Transmission and Drivetrain: All Technical Service Bulletins

Bulletin No.: 67-71-47

Subject:
3-2 Part Throttle Downshift Flare (Replace 3-2 Solenoid)

Models:
1996 Buick Roadmaster
1996 Cadillac Fleetwood
1996 Chevrolet Camaro, Caprice, Corvette
1996 Pontiac Firebird
1996 Chevrolet and GMC C/K, M/L, S/T, G Models
1996 Oldsmobile Bravada
with HYDRA-MATIC 4L60-E (RPO M30)

Figure 1 - Hydra-Matic 4L60-E Transmission Identification Information

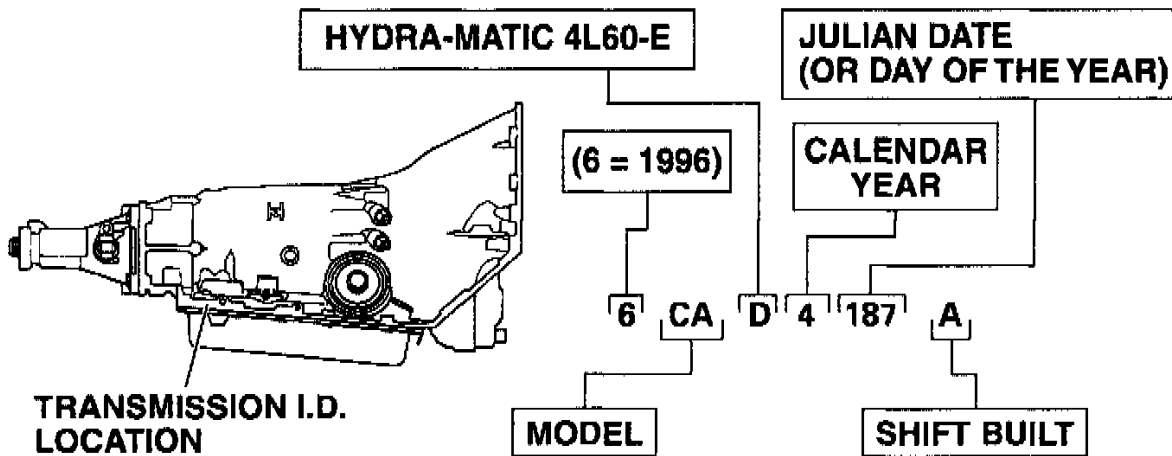
Some owners of the above models with a HYDRA-MATIC 4L60-E transmission (built before May 24, 1996/Julian Date 6145) may experience an engine speed flare of 1000-2000 RPM, during a part throttle downshift at 19-31 mph. This condition will not set any DTC's (Diagnostic Trouble Codes).

Figure 3 - Location and Identification of the 3-2 Control Solenoid on the Control Valve Body

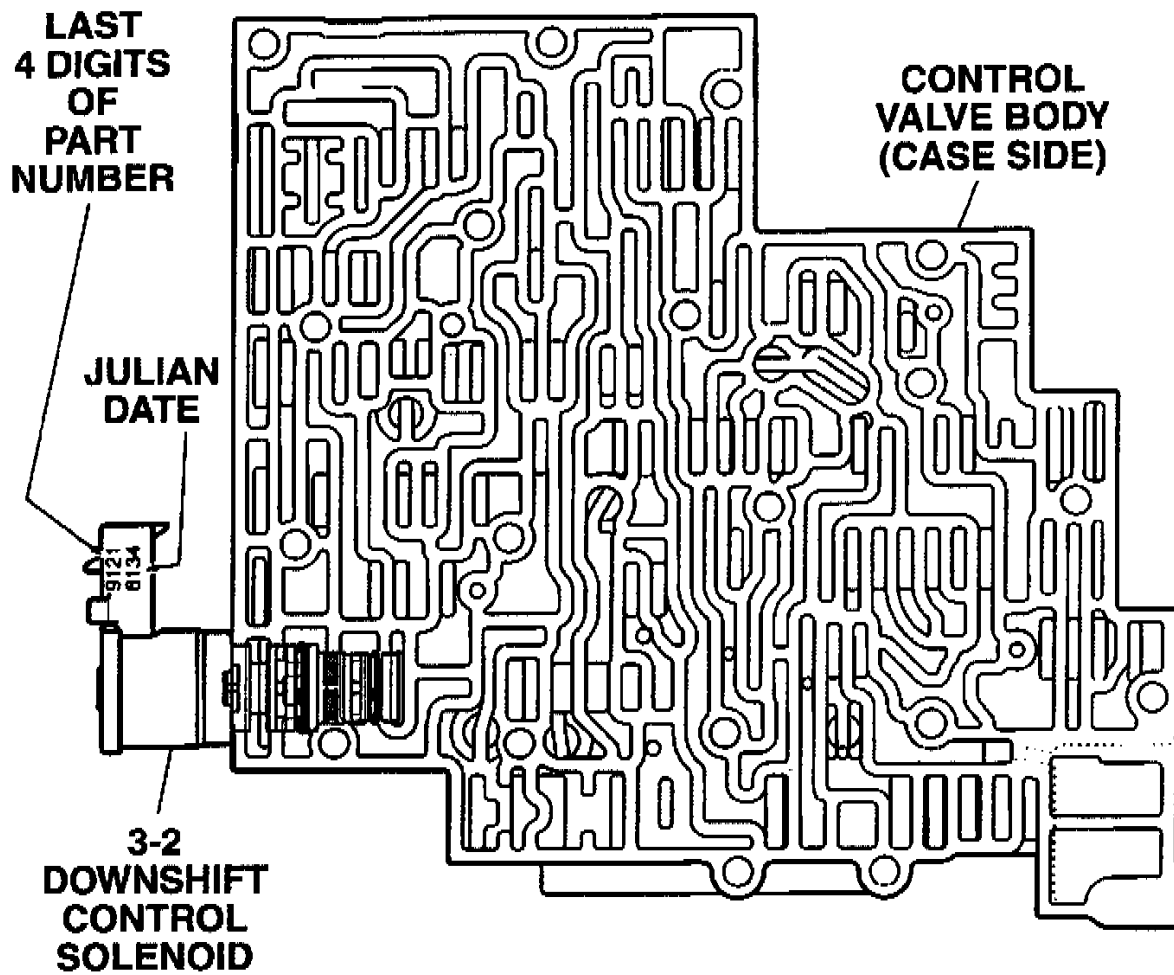
Exhaust seat on the 3-2 control solenoid backing out.

Replace the 3-2 control solenoid. Julian Date on the solenoid will be May 13, 1996 (6134) or later.
